World Forum for Harmonization of Vehicle Regulations

Proposal for Supplement 1 to the 01 series of amendments of UN Regulation No. 154

Submitted by the representatives of the European Commission and Japan *, **

Flowchart of the CoP test procedure for the Type 1 test

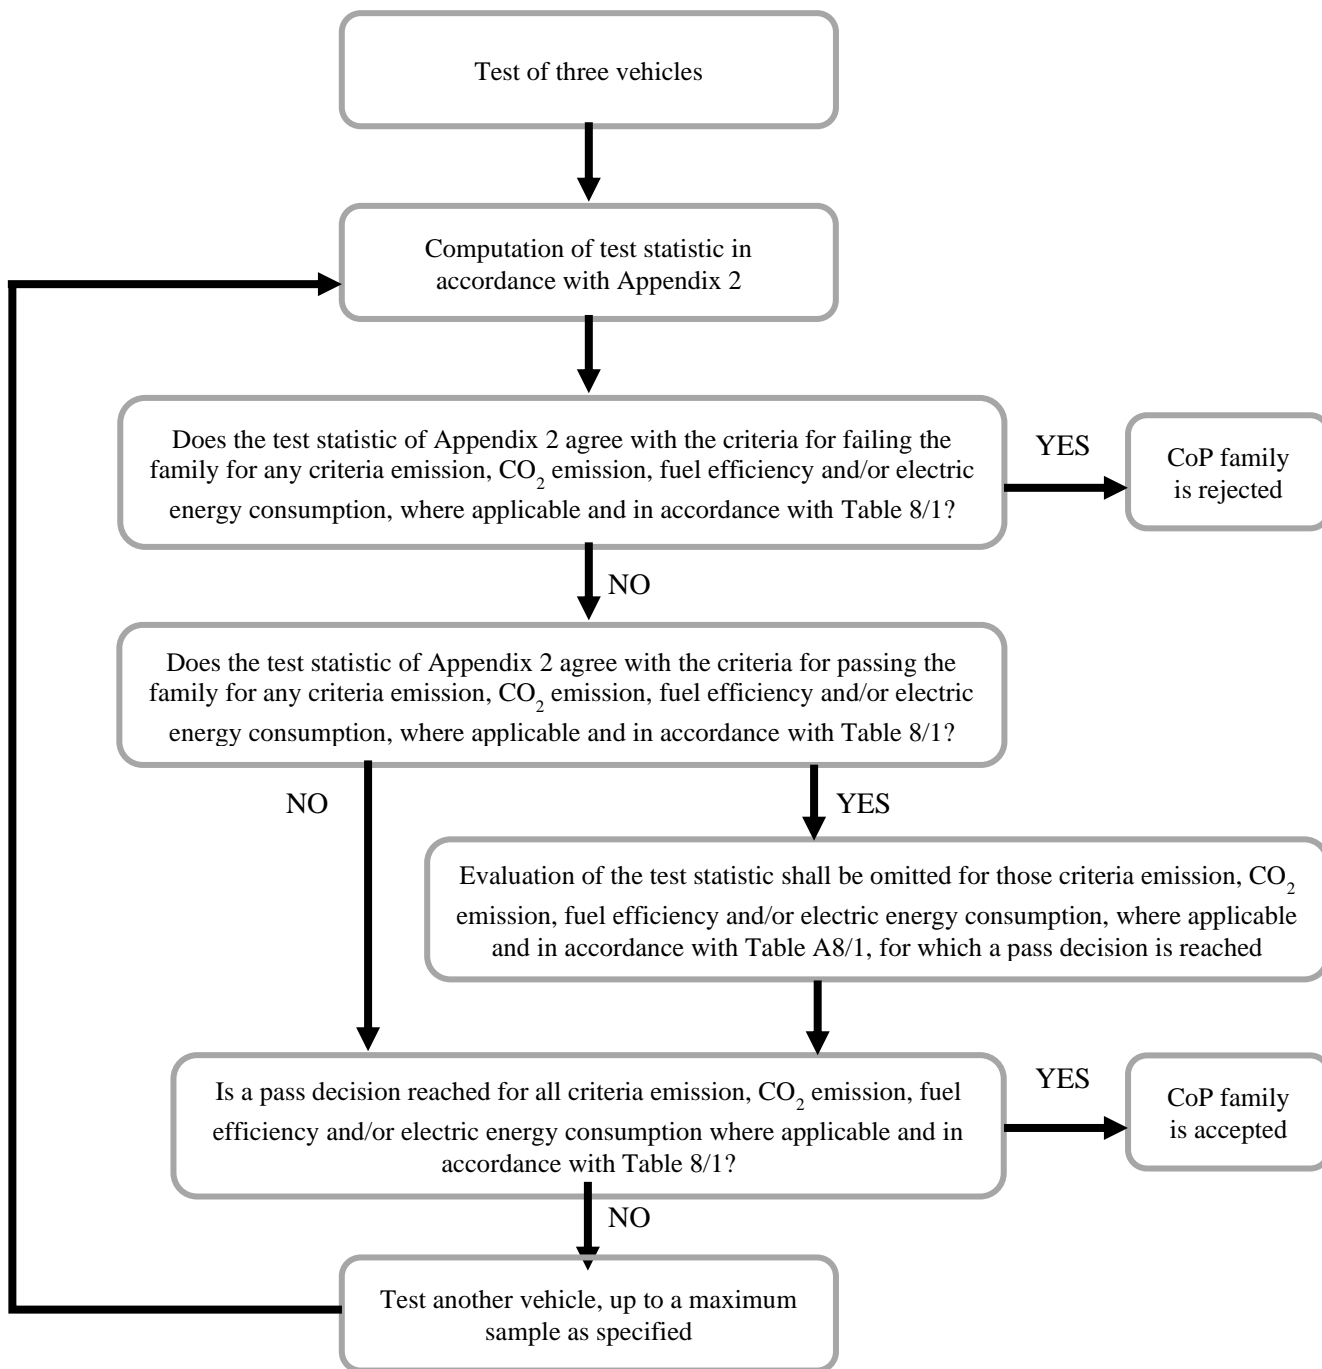
Paragraph 8.2.3.2., Figure 8/1, amend to read:

Figure A6/4

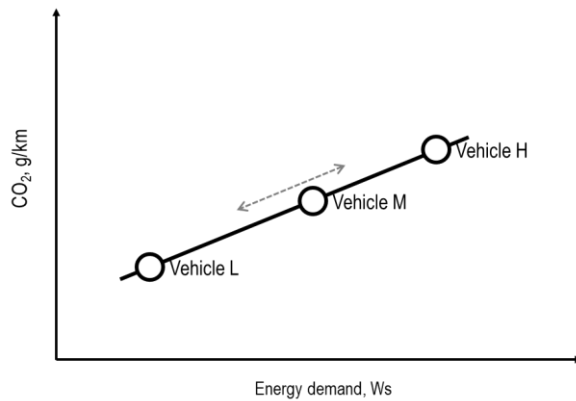
Paragraph 2.3.2.4., amend to read:

The limits of the selection of vehicle M (see Figure A6/4) are such that neither the difference in CO₂ emission values between vehicles H and M nor the difference in CO₂ emission values between vehicles M and L is greater than the allowed CO₂ range in accordance with paragraph 2.3.2.2. of this annex. The defined road load coefficients and the defined test mass shall be recorded.

Figure A8/2

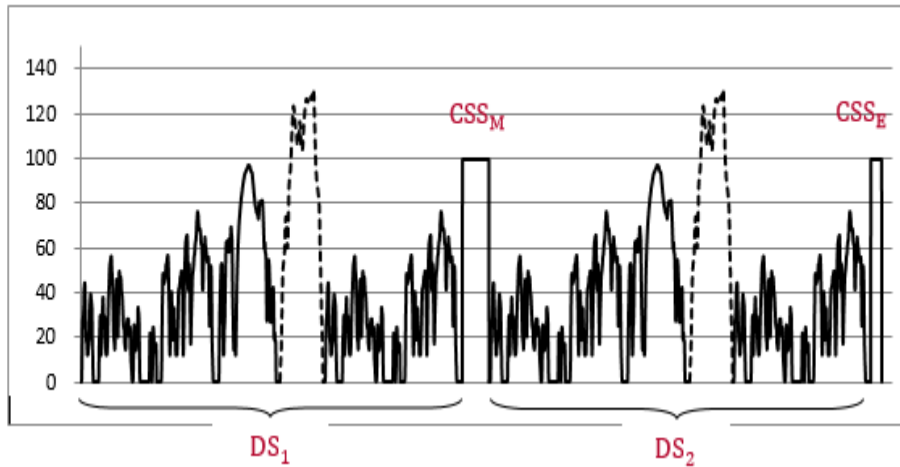
Paragraph 3.4.4.2.1., amend to read:

The shortened Type 1 test procedure consists of two dynamic segments (DS₁ and DS₂) combined with two constant speed segments (CSS_M and CSS_E) as shown in Figure A8/2.

Figure A8/5

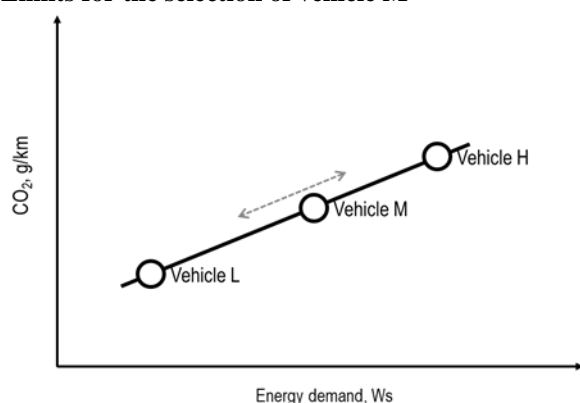
Paragraph 4.5.1.1.5., amend to read:

The limits of the selection of vehicle M (see Figure A8/5) are such that neither the difference in CO₂ mass emission between vehicles H and M nor the difference in charge-sustaining CO₂ mass emission between vehicles M and L is higher than the allowed charge-sustaining CO₂ range according to paragraph 4.5.1.1.2. of this annex. The defined road load coefficients and the defined test mass shall be recorded.
